TECHNICAL SERVICE BULLETIN

TB08-102 R-M

**TO: NORDYNE DISTRIBUTORS
NORDYNE DEALERS**
FROM: TECHNICAL SERVICE DEPARTMENT
DATE: February 11, 2008
RE: Chattering Check Valve on the GB5BW Air Handlers

632392R - Magnet Kit GB5BW

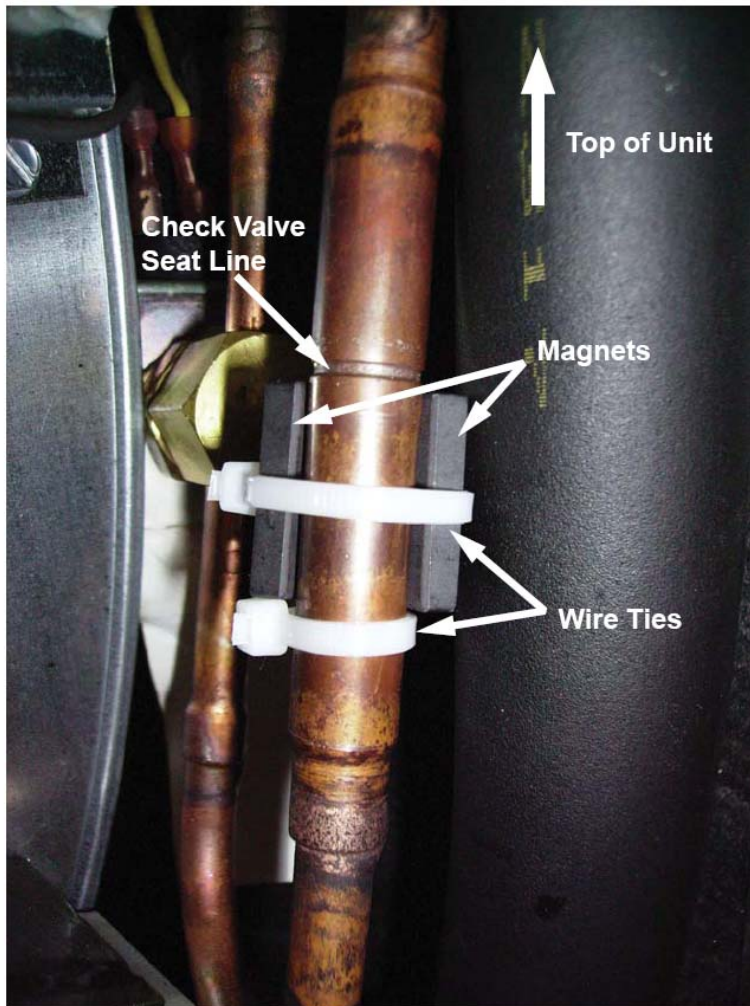
Nordyne has received reports of **GB5BW** air handlers that have a chattering or rattling noise in the coil. The noise is caused by a missing spring in the check valve assembly.

In the interim Nordyne recommends that a magnet kit (632392R) should be use to correct the noise issue. Attached are the Installation Instructions for the magnet kit.

Locate the magnets as shown with the top of each magnet at or slightly below the check valve seat mark on the check valve body.

The top wire tie serves to hold the magnets against the check valve body.

The bottom wire tie can be replaced by tar tape or any other means of preventing the magnets from slipping down the in the check valve.
